Bulletin No. 2002-14

## Erratic Steering – Excel Models

All Excel Models

00177

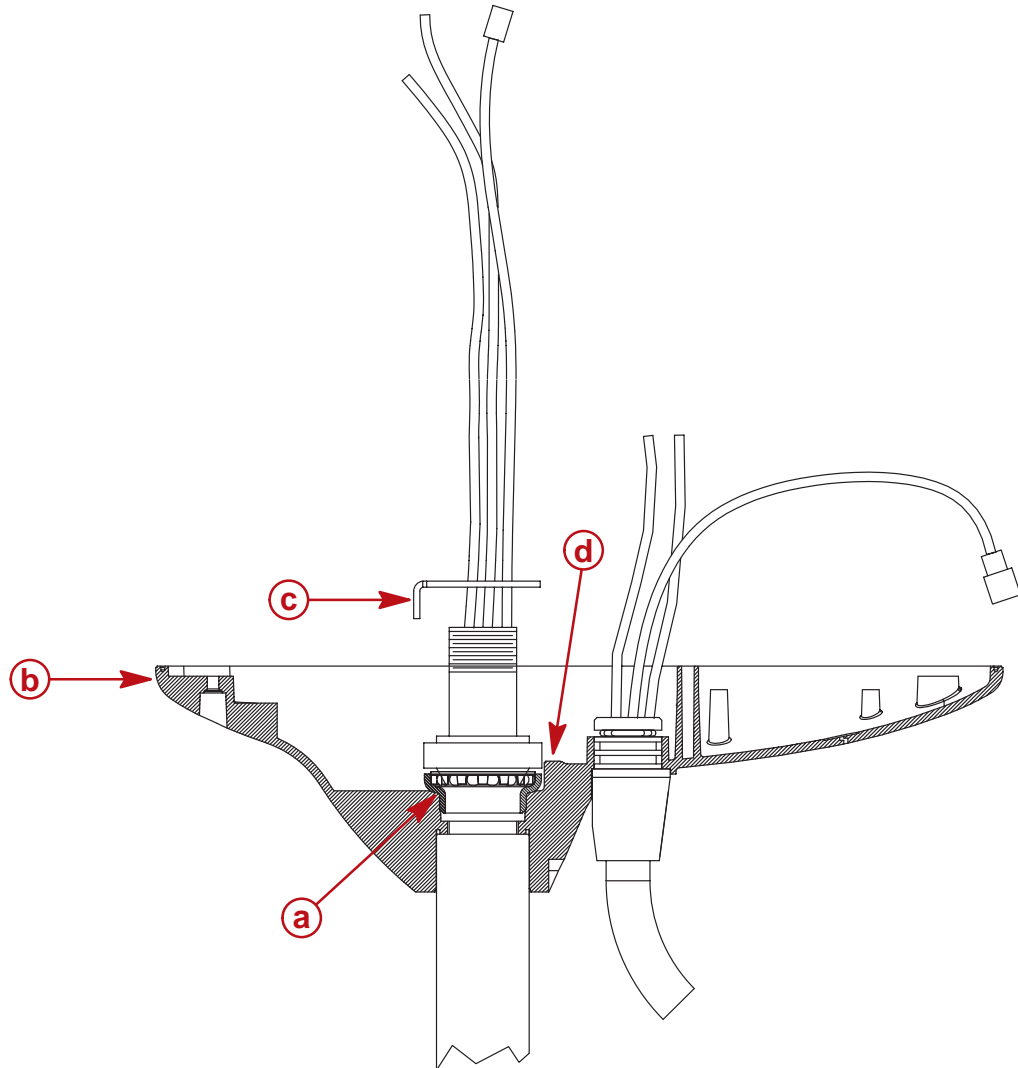
If the steering performs erratically, it is possible that the steering bearing cup is not pressed completely into the lower housing base. This condition could manifest itself in two ways:

1. The motor may have erratic steering from full left to full right.
2. The motor may steer in only one direction until it reaches the limit of its travel, where it will remain until power is removed from the motor.

Check the steering bearing cup in the lower housing. If it is not fully installed, press it into place and also replace the steering positioning pot (P/N 84-M01128). If when the bearing cup is properly installed, the stop washer turns past the mechanical stop, it is also necessary to replace the lower housing.
